Access Compliance Report

Public Rights-of-Way

Intersection ID: 27903	Main Street: ALEXANDER_MILL_DR	Cross Street: BALLANTYNE_COUNTRY_CLUB_DR	Location: NE
ADA ID: AF61768C2AF0	Ramp Type: Perp	Initial Pass/Fail: Fail	Overall Compliance: No
		Severity Score: 25

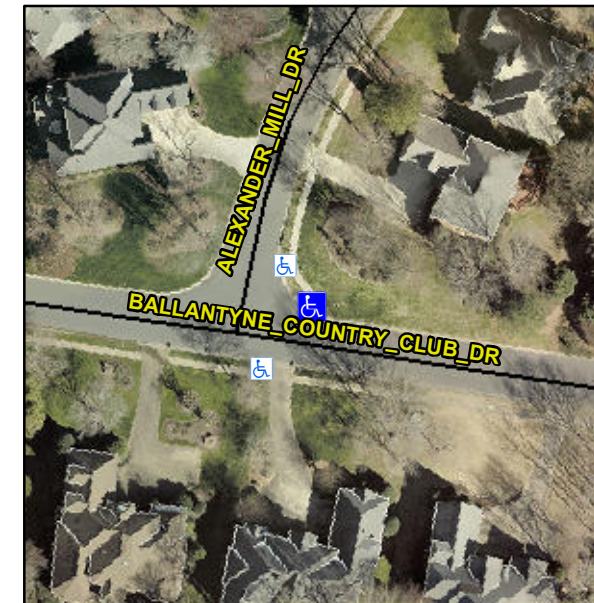
Not Found, R304.5.3

Compliance	Description	Data	Compliance	Description	Data
N/A	Ramp Length (in)	51.0	Yes	Ramp Slope (%)	6.3
Yes	Ramp Width (in)	48.0	No	Ramp XSlope (%)	9.2
N/A	Flare Type LT	N/A	N/A	Flare Type RT	N/A
N/A	Flare Slope LT (%)	N/A	N/A	Flare Slope RT (%)	N/A
N/A	Flare Traversable LT?	N/A	N/A	Flare Traversable RT?	N/A
N/A	Landing Length (in)	N/A	N/A	DWS Provided?	N/A
N/A	Landing Width (in)	N/A	N/A	DWS Contrast?	N/A
N/A	Landing Slope (%)	N/A	N/A	DWS Length (in)	N/A
N/A	Landing X Slope (%)	N/A	N/A	DWS Full Width?	N/A
N/A	Landing Curb? (Y/N)	N/A	N/A	DWS Offset (in)	N/A
N/A	Shared Landing?	N/A			
N/A	Gutter Ponding?	N/A	N/A	Gutter Slope (%)	N/A
N/A	Gutter Lip Ht (in)	N/A	N/A	Gutter X Slope (%)	N/A
N/A	Painted X Walk1?	No	N/A	Painted X Walk2?	N/A
	X Walk 1 Direction	To SW		X Walk 2 Direction	N/A
N/A	X Walk 1 Width (in)	N/A	N/A	X Walk 2 Width (in)	N/A
	X Walk 1 Slope (%)	2.4		X Walk 2 Slope (%)	N/A
	X Walk 1 X Slope (%)	6.0		X Walk 2 X Slope (%)	N/A

Remove & Replace Entire Ramp.
